FlexPLI Rebound Phase

7th IG GTR9-PH2 Meeting
3/July/2013

Japan Automobile Standards Internationalization Center (JASIC)

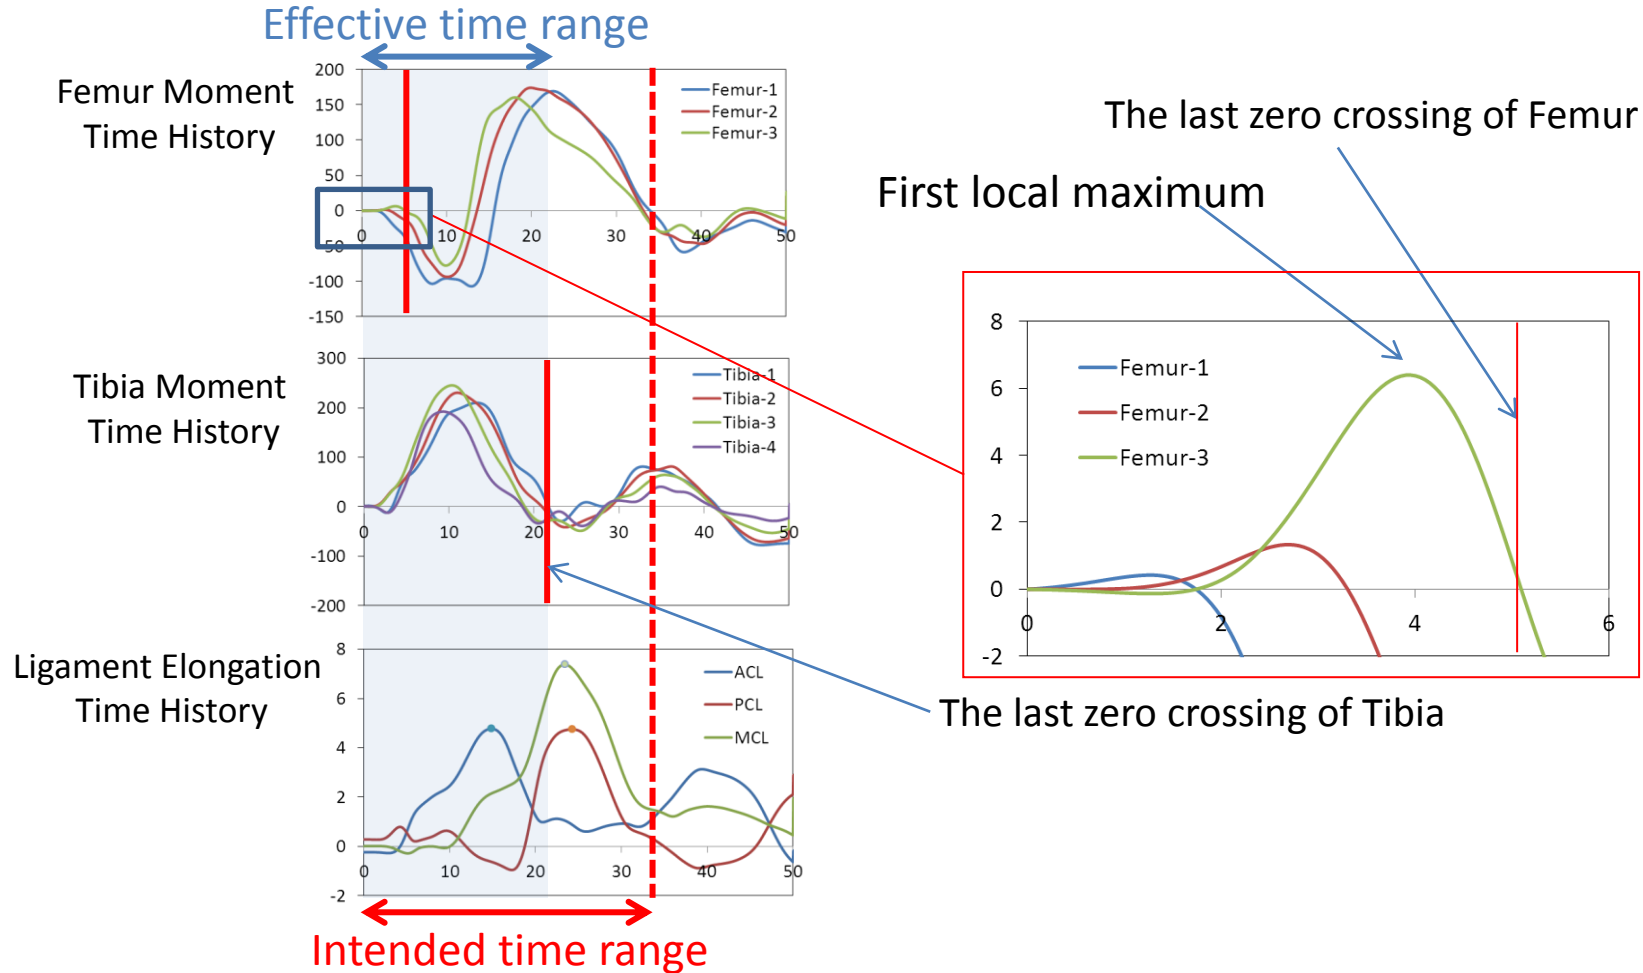
Definition of Timing

The BAST definition may result in an unexpected definition of the effective time range

The definition of the first local maximum needs to be modified
